## ADDENDUM

Date February 2, 2024

Re Addendum No. 3 to the Construction Documents for:

Dorthea Dix Psychiatric Campus  
Pooler Pavilion Abatement  
Bangor, Maine  
Project No. 23134

Revision Date	Revision Description

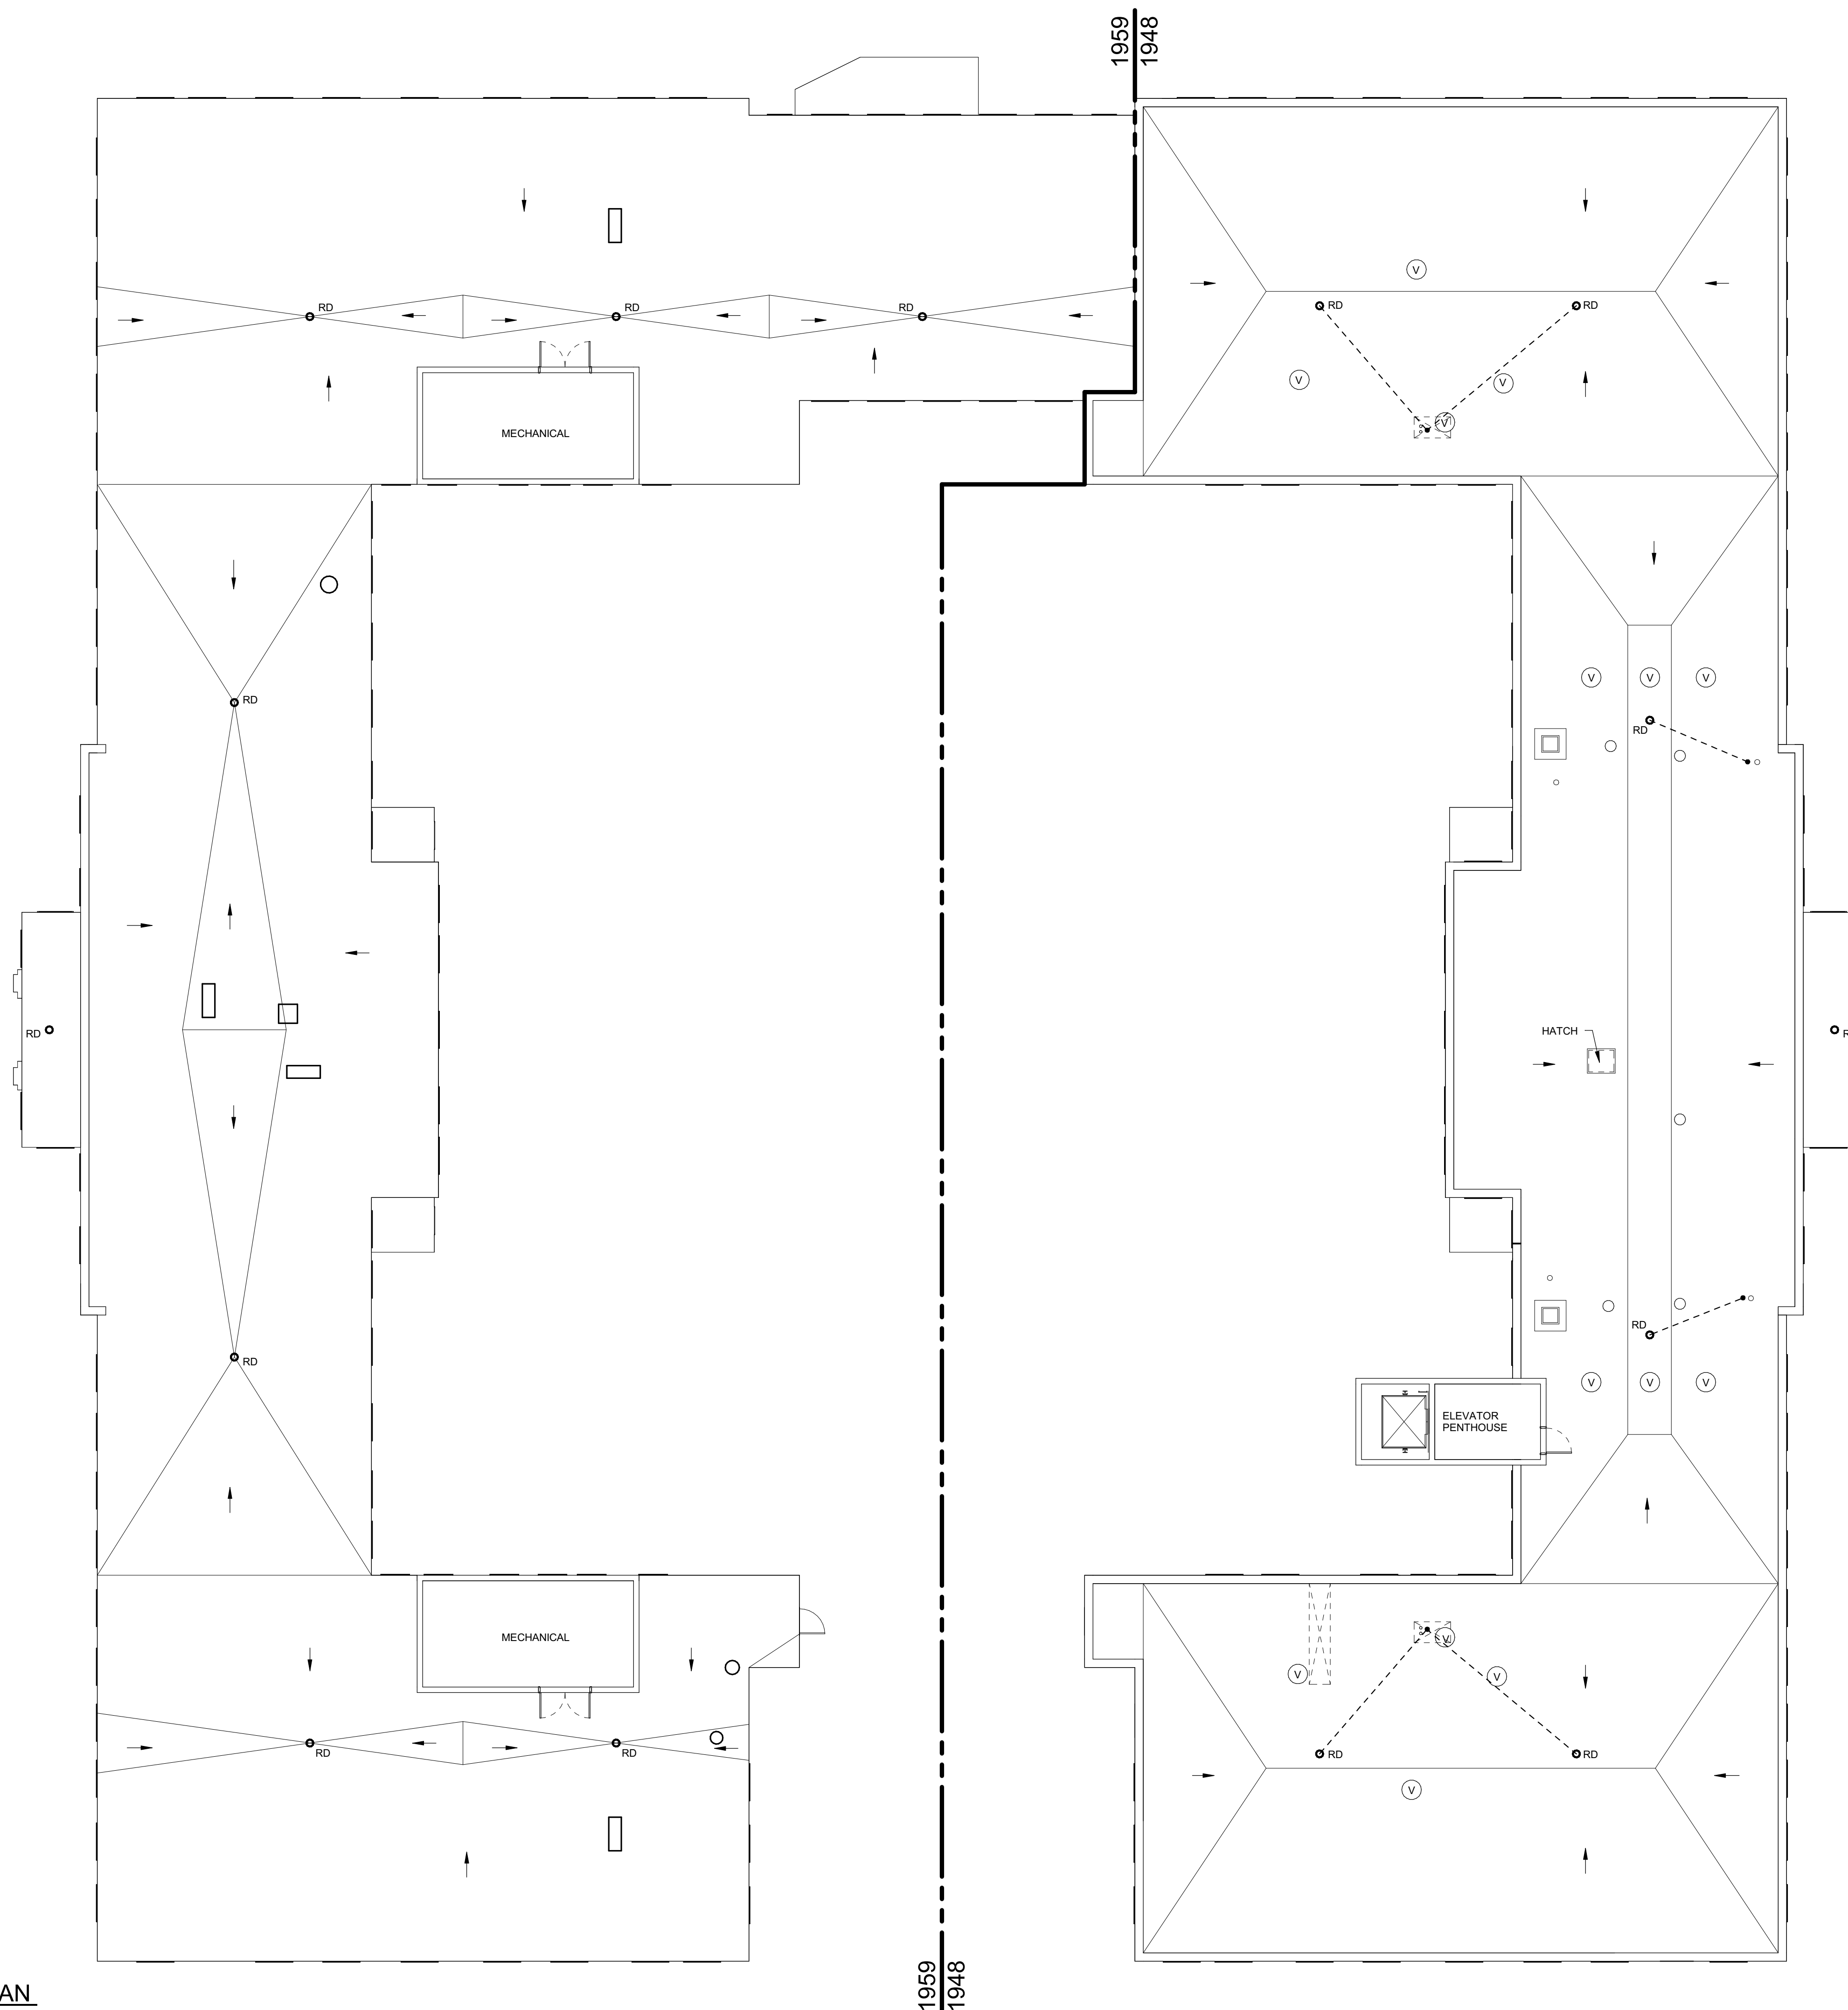
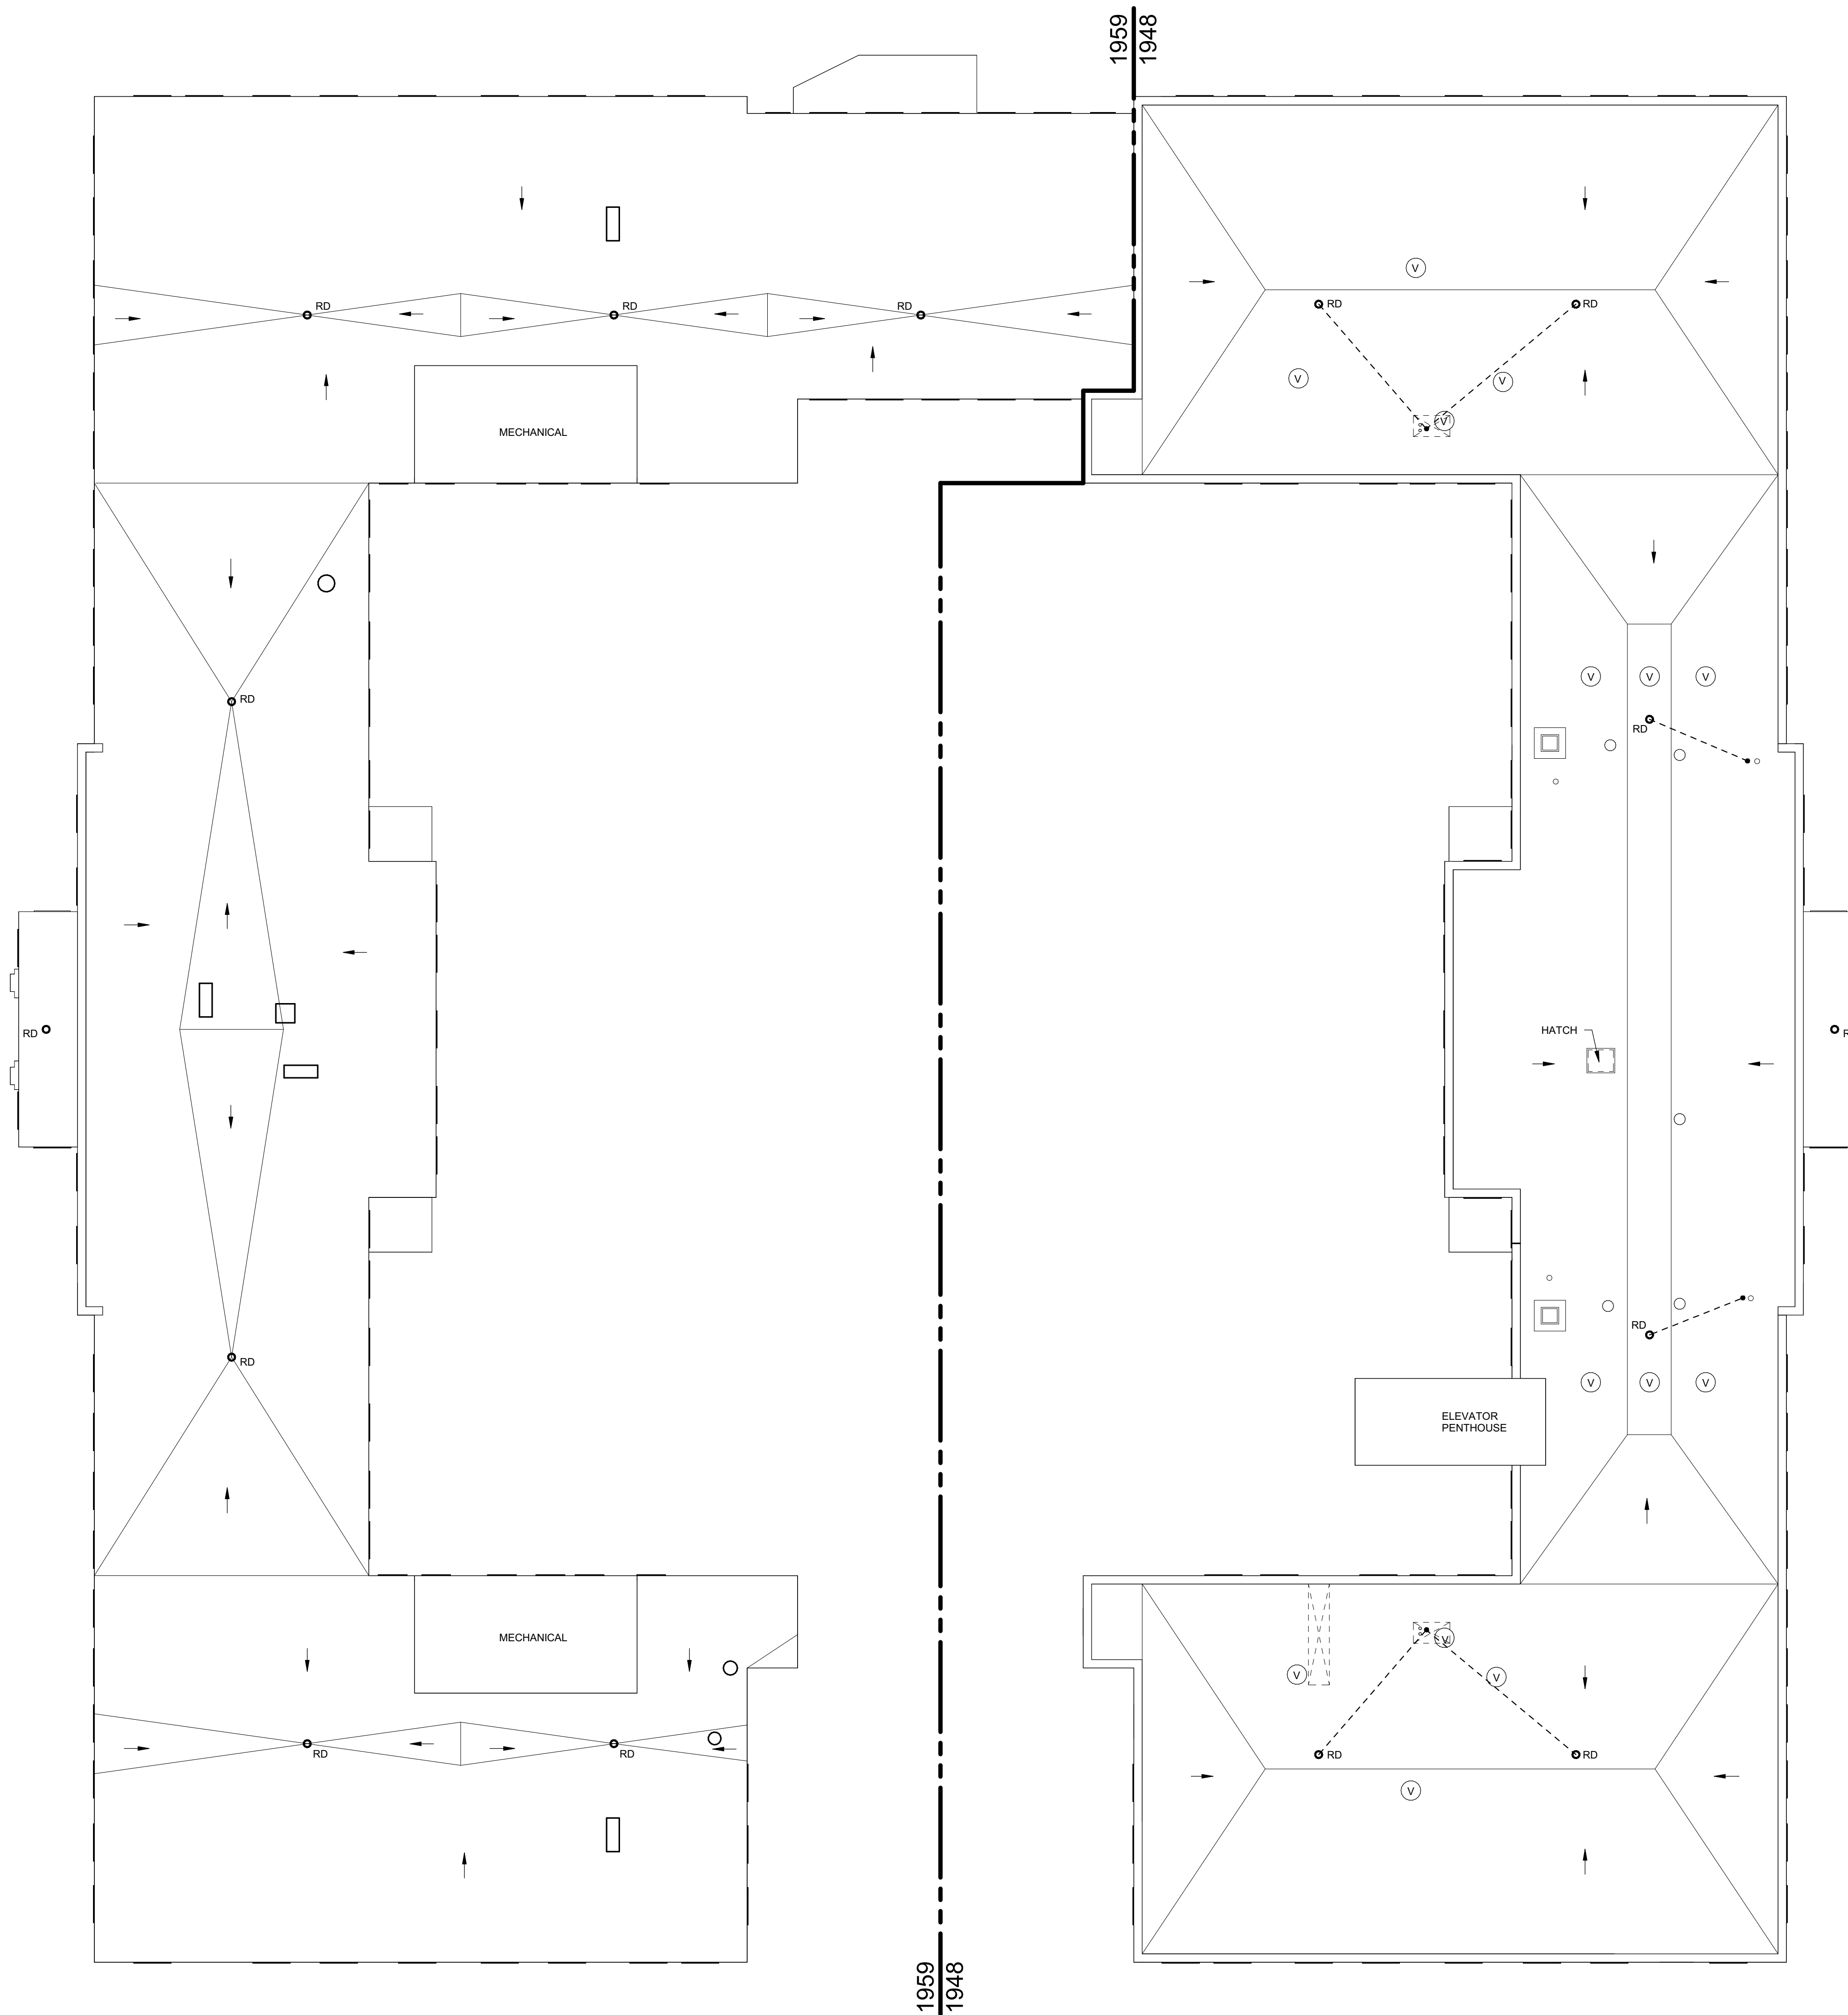
Q6: Please confirm permanent power will be provided at no charge to the contractor.

Q7: Water is required for MDEP asbestos worker decontamination showers. Will any water service be available for this project?

Q18: Will the Owner perform grubbing and cut back of the excess vegetation & trees to allow for access to the outside of the building (i.e.. windows, doors, etc.) requiring exterior caulking removal?

**See notation for location of proposed temporary electrical patch panel on floor plan reference drawings provided with this addendum.**

**See notation for location of proposed temporary domestic water connection on the floor plan reference drawings provided with this addendum.**

**A18: No. Site and building to be considered 'as is'. Existing vegetation in immediate proximity to the building and in the courtyard does not need to be preserved. See site diagram in attached floor plan documents issued for reference with this Addendum.**
